ECE/TRANS/WP.29/2009/129
28 August 2009

Proposal for the 02 series of amendments to Regulation No. 64
(Temporary-use spare wheels/tyres)

Submitted by the Working Party on Brakes and Running Gear */

Model A

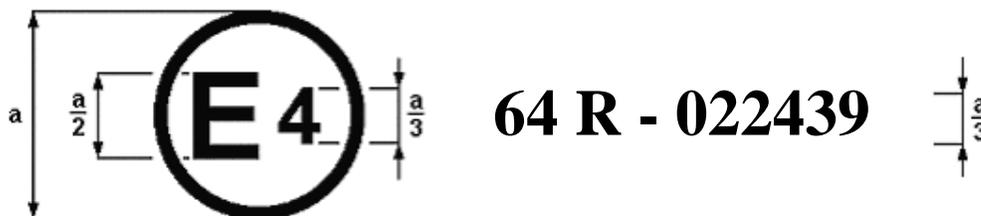
Annex 2, amend to read:

The above approval mark affixed to a vehicle shows that the vehicle type concerned has, with regard to the equipment of temporary-use spare unit(s), been approved in the Netherlands (E 4), pursuant to Regulation No. 64 under approval number 022439. The approval number indicates that the approval was granted in accordance with the requirements of Regulation No. 64, incorporating the 02 series of amendments.

Model B

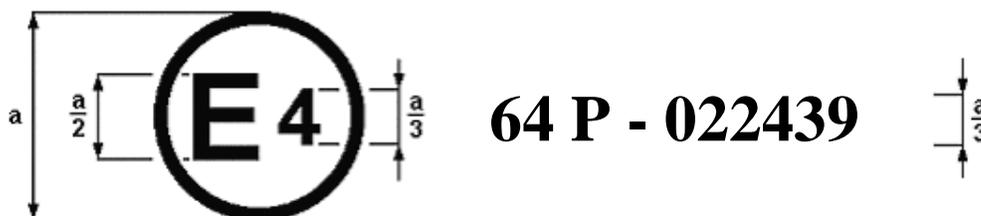
The above approval mark affixed to a vehicle shows that the vehicle type concerned has, with regard to the equipment of a tyre pressure monitoring system, been approved in the Netherlands (E 4), pursuant to Regulation No. 64 under approval number 022439. The approval number indicates that the approval was granted in accordance with the requirements of Regulation No. 64, incorporating the 02 series of amendments.

Model C

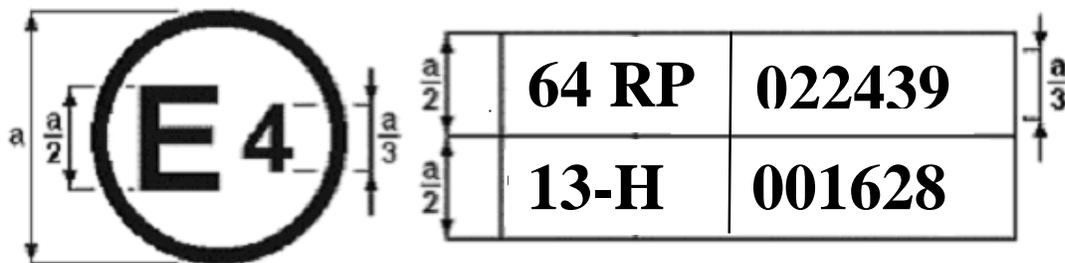
The above approval mark affixed to a vehicle shows that the vehicle type concerned has been approved in the Netherlands (E 4) pursuant to Regulation Nos. 64 (with respect to the equipment of temporary-use spare unit(s) and equipment with a tyre pressure monitoring system) and 13-H. ^{1/} The approval numbers indicate that, at the dates when the respective approvals were given, Regulation No. 64 included the 02 series of amendments and Regulation No. 13-H was in its original form.
